UNITED STATES ENVIRONMENTAL PROTECTION AGENCY

Re: PCB Risk-Based Disposal Approval under 40 CFR § 761.61(c)
Former Polymerine Site
241 Duchaine Boulevard, New Bedford, MA
MassDEP RTN: 4-1347

PCB RISK-BASED DISPOSAL APPROVAL CONDITIONS FORMER POLYMERINE SITE (“the Site”) 241 DUCHAINE BOULEVARD, NEW BEDFORD, MA

ADDENDUM NO. 2 - FIGURE 1 PROPOSED BUILDING MATERIALS MANAGEMENT PLAN

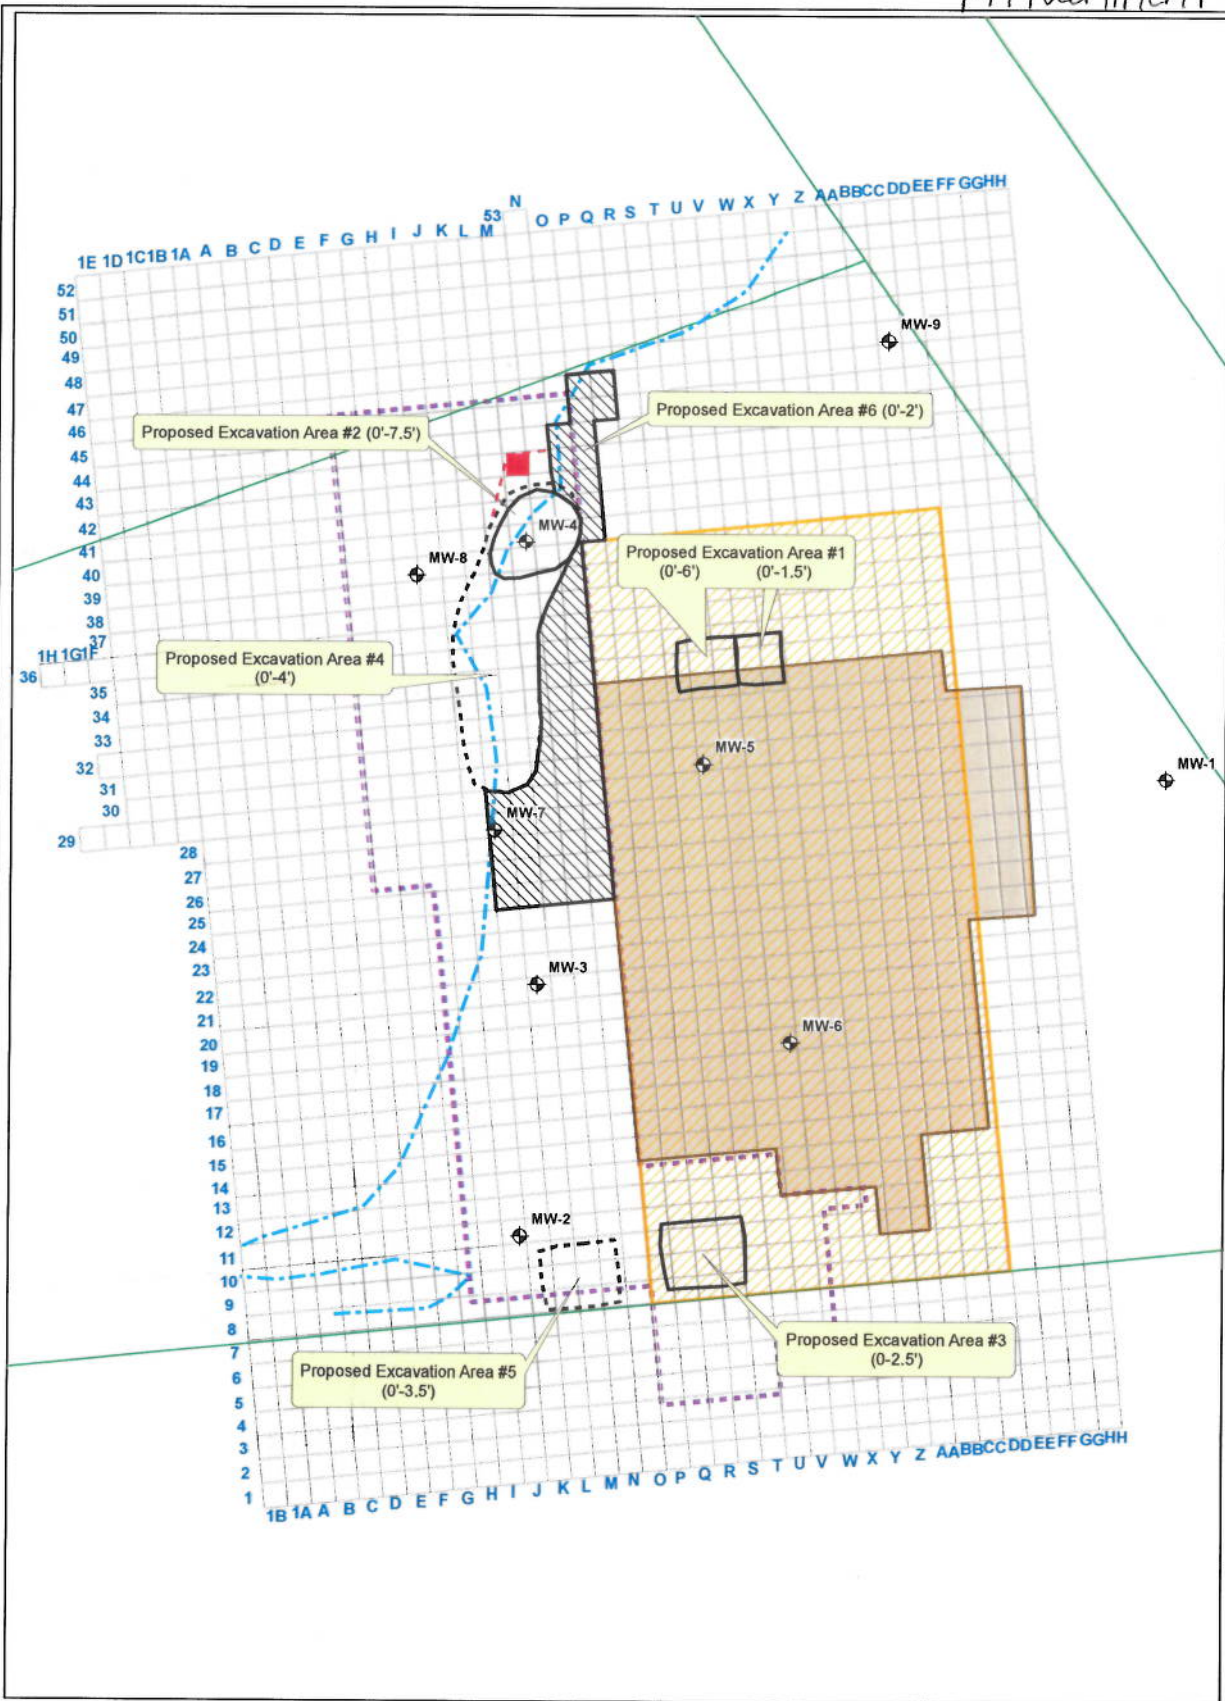
- Remove *PCB bulk product waste* (e.g., caulk and 12 inches of adjacent brick) and dispose off-site in accordance with 40 CFR § 761.62
- Remove *PCB remediation waste* (i.e., northern end painted and oil-stained CMU walls and greater than or equal to (\geq) 500 parts per million (“ppm”) PCBs concrete floor) and dispose off-site in accordance with 40 CFR § 761.61(a)(5)(i)(B)(2)(iii)

- Place < 500 ppm *PCB remediation waste* associated with the former building (i.e., uncoated/unpainted concrete outside of former boiler room) into the consolidation area where a TSCA-compliant cap will be constructed

The City has determined that certain building materials (i.e., painted, non-oil stained concrete masonry unit (“CMU”) walls) which have PCB concentrations at < 50 ppm, meet the definition of *Excluded PCB Products* as defined under 40 CFR § 761.3. These materials will be removed and disposed of under the Massachusetts Department of Environmental Protection (“MassDEP”) Regulations.
